# Technical Service Information

## **FORD A4LD DIRECT CLUTCH FAILURE DELAY IN REVERSE**

Figure 1

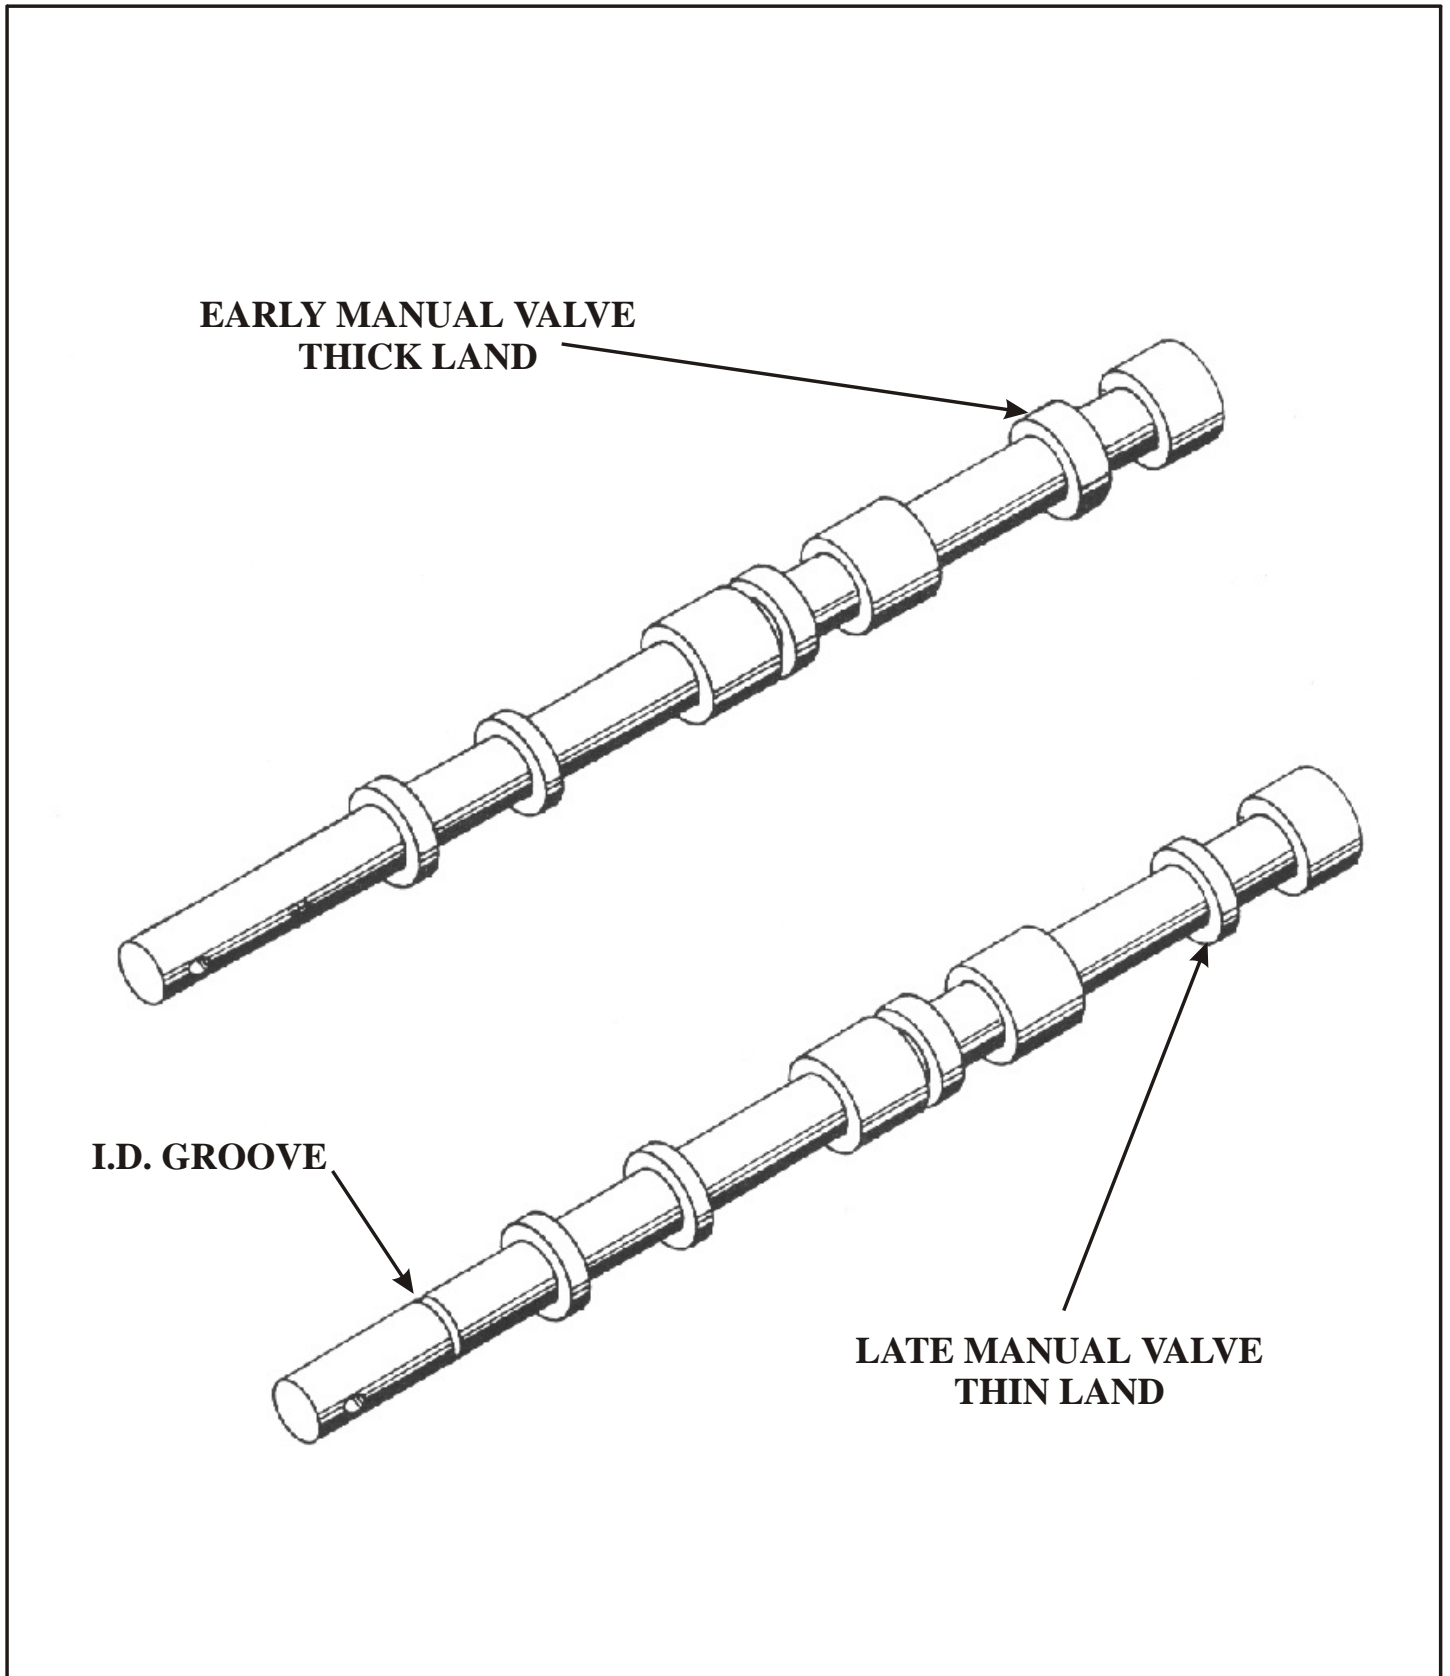
**CORRECTION:** There is now a new design manual valve available for service, and can be identified by a groove on the valve stem just behind the manual valve link hole (See Figure 1). The 2nd design manual valve has a thinner land on it, as shown in Figure 1, and went into production vehicles in January, 1988.

**SERVICE INFORMATION:**  
Manual Valve (2nd Design)..... E8TZ-7C389-A
